RESIDENTIAL SUBDIVISION ENTRANCE/ACCESS DESIGN STANDARDS

Re: Leon Reserve Phase II Final Plat Application – Subdivision Entry Standards

Subject: Traffic Impact Analysis

Access Point 1 – Aguayo Way

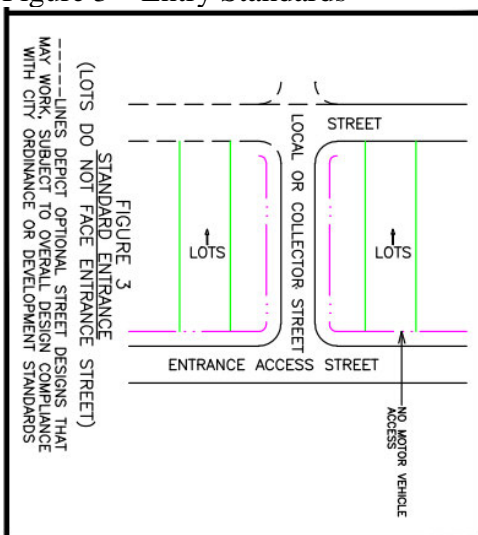
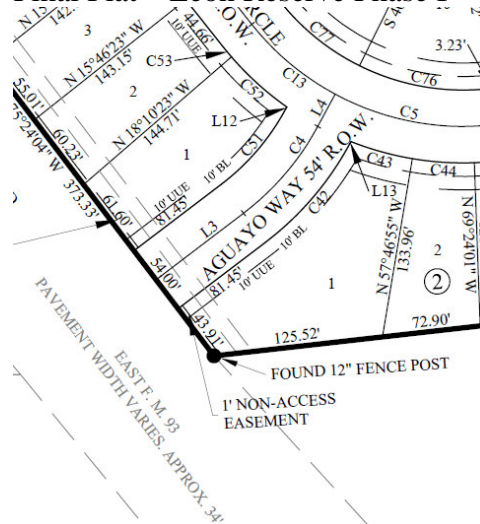
Aguayo Way is a 54' right-of-way, which will be built as a collector street. It adjoins East F.M. 93, Entrance Access Street, and no lots on Aguayo Way face the entrance street. WBW designed the pavement to be forty-one feet (41') BOC, which could qualify it as either Figure 3 or Figure 5 (and be the equivalent of two entrances). Because WBW presumes that only one entry may be considered as a two-entry equivalent, WBW takes the position that Aguayo Way meets the minimum standard to be counted as an entry as described by Figure 3.

Access Point 2 – Cross Timbers Boulevard

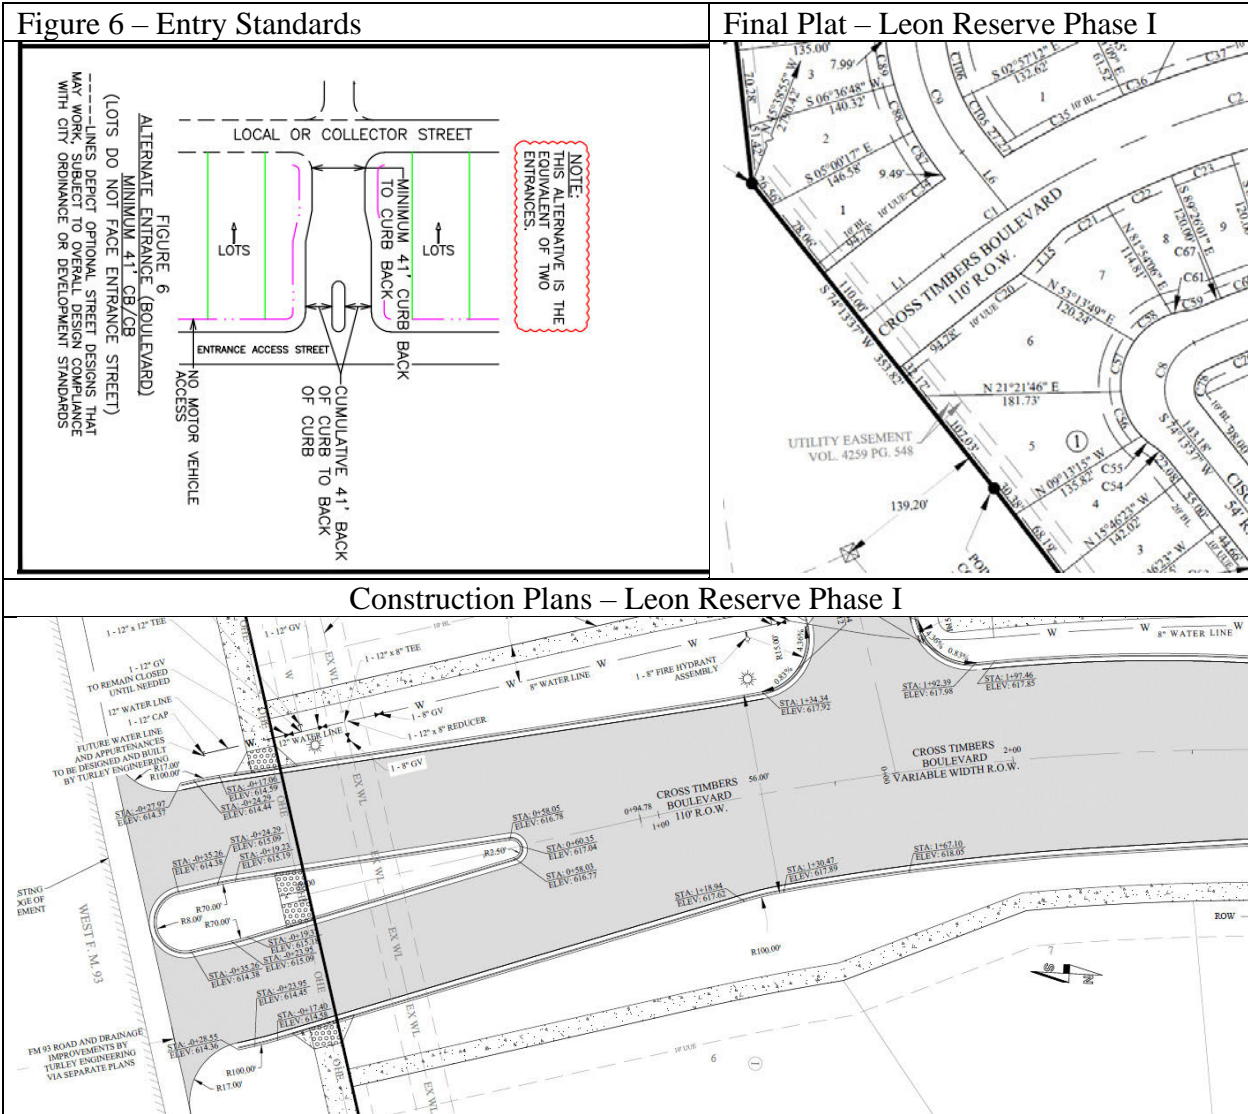
Cross Timbers Boulevard exceeds the minimum width requirements to be treated as Figure 6 in the Entry Standards, counting as the equivalent of two entrances. It is a one hundred ten foot (110') right of way, containing two drives, separated by an eighteen foot (18') median. Each drive is twenty-eight feet (28') back of curb to back of curb (56' cumulative). No lots front Cross Timbers Boulevard, which will be constructed as a neighborhood collector. Further, WBW reserved additional right-of-way for the City to expand the road to a community collector, should a future need for expansion arise from the development of adjoining properties. As established by the Entry Standards, Cross Timbers Boulevard meets the requirements of Alternative design Figure 6 and is the equivalent of two entrances.

Phase I – Cross Timbers Boulevard Eastern Connection¹

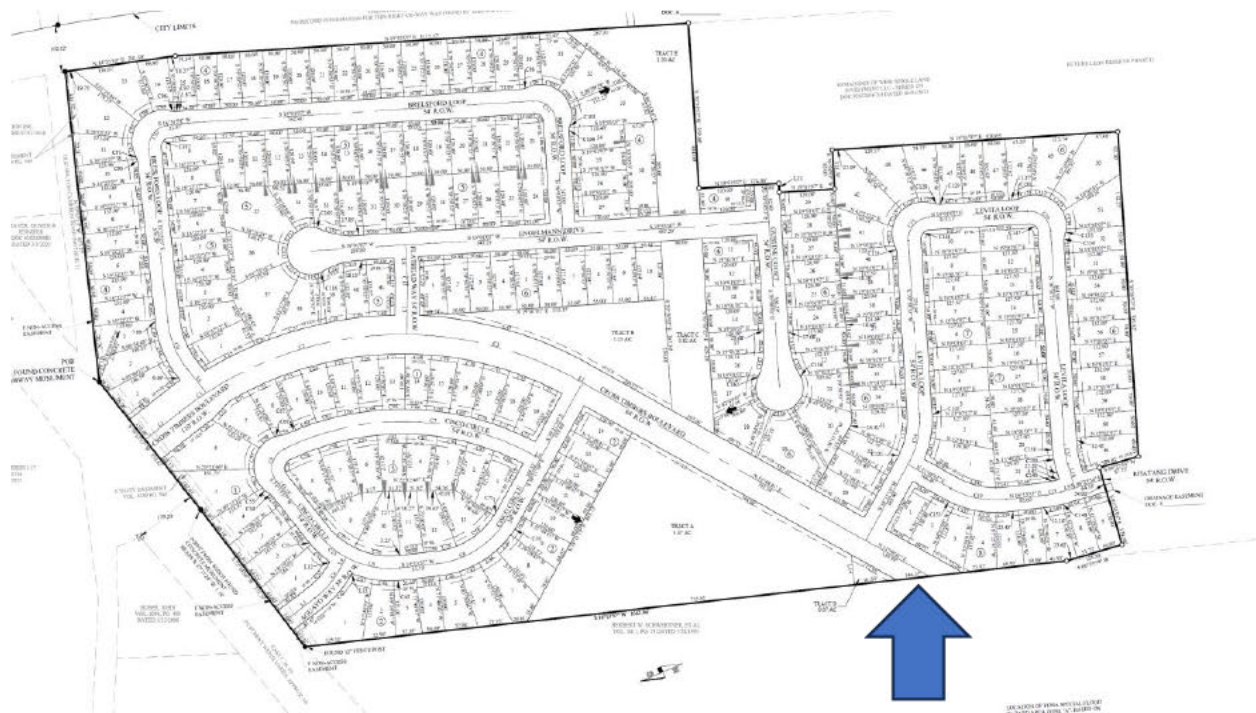
The eastern connection via Cross Timbers Boulevard is significant for addressing the access needs for any future development for two reasons. First, the right-of-way will accommodate a community collector (as stated above). Second, BellCAD ID 140178 contains 937.9 feet of frontage to FM 93, providing ample room for additional access points when the parcel is developed.

Phase II – Lamkin Drive²

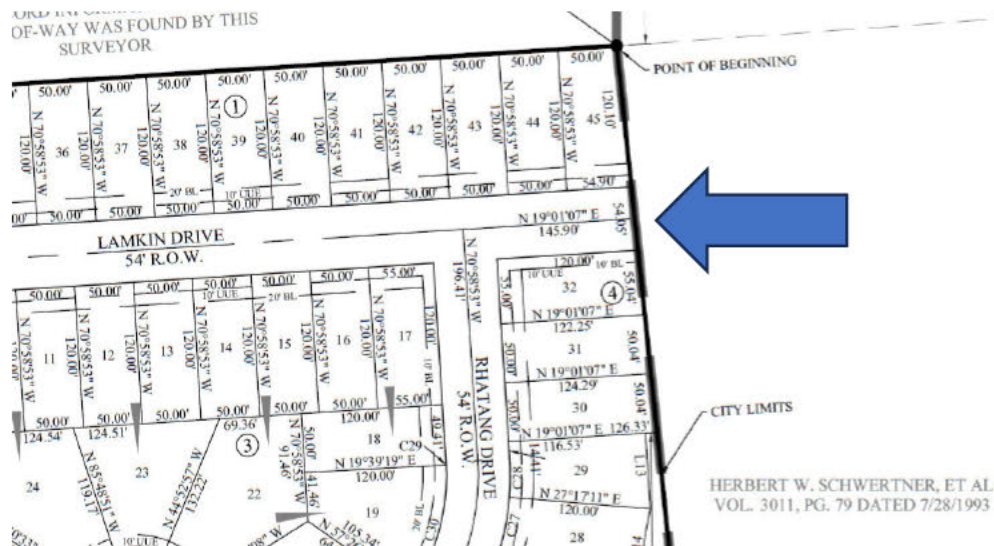
Like Cross Timbers Boulevard, WBW stubbed a right-of-way to the northern parcel owned by Schwertner, BellCAD ID 104180. Both of these streets may satisfy additional access requirements because they are components of an approved Preliminary or Final Plat. WBW believes that the eastern connection, with its additional frontage to FM 93, satisfies the intent of the Entry Standards and adequately addresses future traffic needs in the area as development proceeds.

Turley Plans (30% review – original alignment of Spur 93 highlighted in yellow)

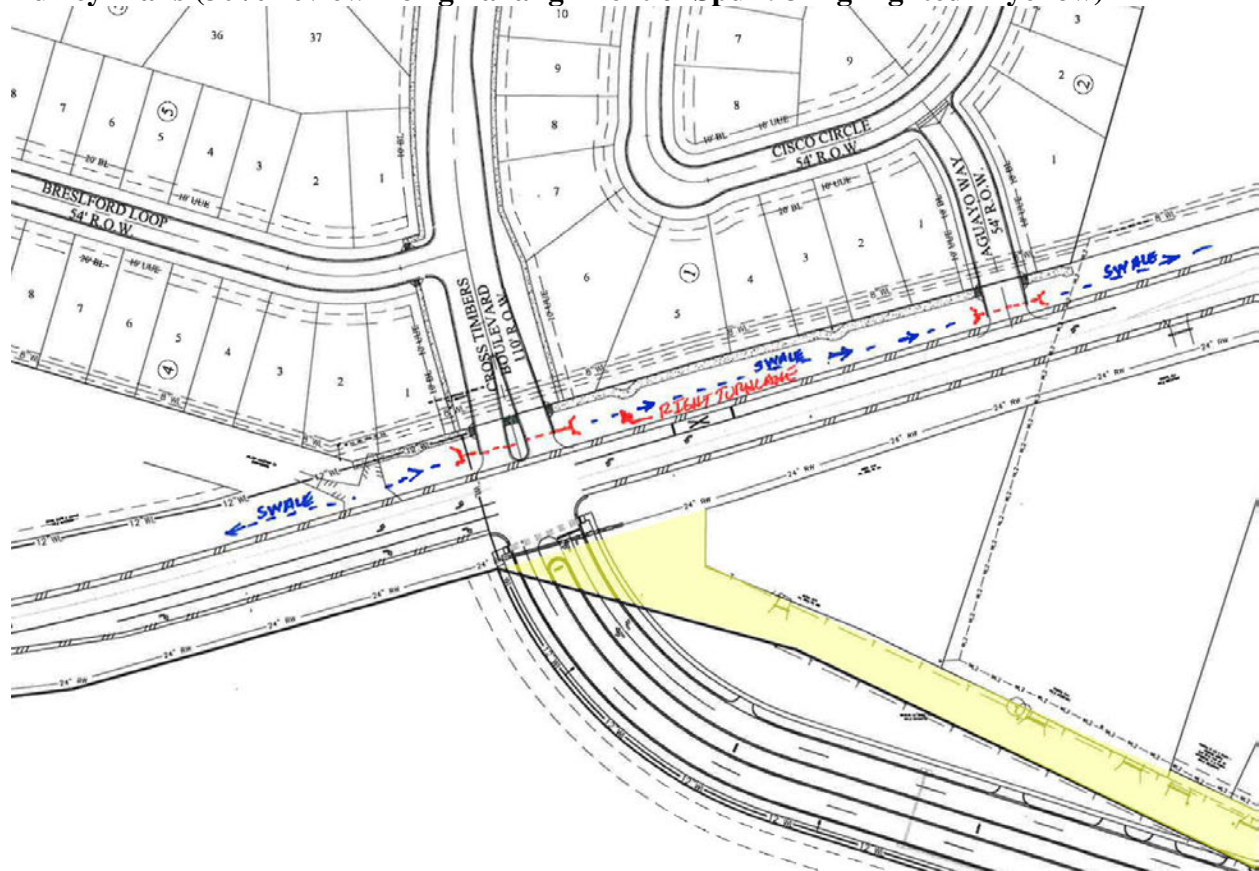
Turley Engineering is designing improvements to the FM 93 / Spur 93 intersection that will incorporate several traffic-enhancing features. When warrant conditions are met, a traffic signal will be installed at the Cross Timbers Boulevard / FM 93 intersection.

As shown above, the proposed realignment of FM 93 spur will include continuous left and right turn lanes, deceleration lanes, and will provide direct access to a multi-lane arterial street.
